City of El Paso - City Plan Commission Staff Report

Case No: SUSU12-00020 Paseo del Este Boulevard Unit One

Application Type: Major Preliminary **CPC Hearing Date:** April 5, 2012

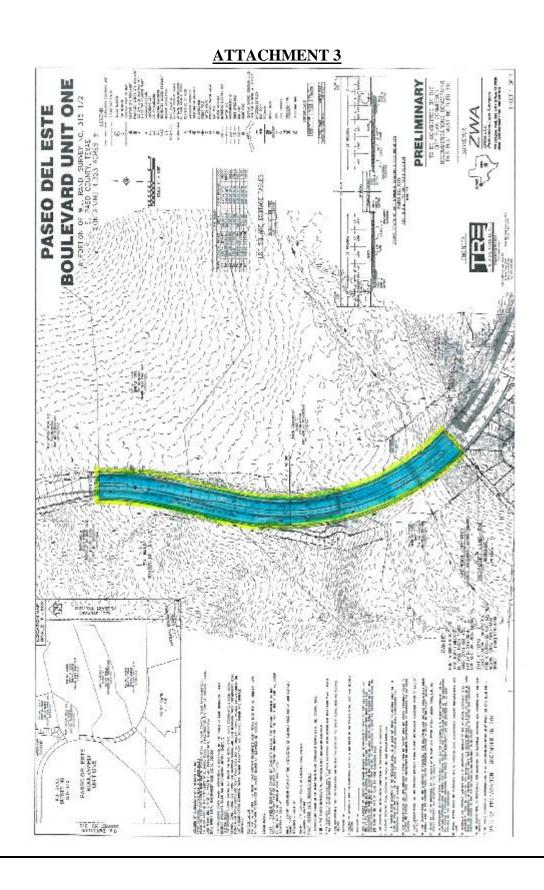
- 1. Provide complete Water, Sewer, and Drainage Engineering Report for ETJ requirements (NOTE: FOR FINAL ONLY).
- 2. Concrete Structure with Energy Dissipater at the Up and Down Stream of the flow path will be required to control the future erosion at the proposed Box Culvert Structure on Paseo Del Este Boulevard.
- 3. All public improvements shall be complied with the **Drainage Design Manual DDM** and **Design Standards for Construction DSC**.

- 2. There is an existing twenty-four (24) inch water line that extends along the alignment of Paseo Del Este Boulevard approximately eighteen (18) feet north of the centerline. The water line has from 5 to 8 feet cover (top of ground to top of pipe) along this section of Paseo Del Este Boulevard. Typically twenty-four (24) inch water lines have 5-feet of cover (top of ground to top of pipe).

- 3. During the subdivision improvement work, the Owner/Developer shall safeguard the existing water main and appurtenant structures. The Owner/Developer shall minimize changes in grade above or near the vicinity of the existing PSB facilities and is responsible for the cost of setting appurtenant structures to final grade. The proposed gradeline of Paseo del Este Boulevard shall satisfy the EPWU-PSB standards for pipeline cover along and over the existing 24" water main.
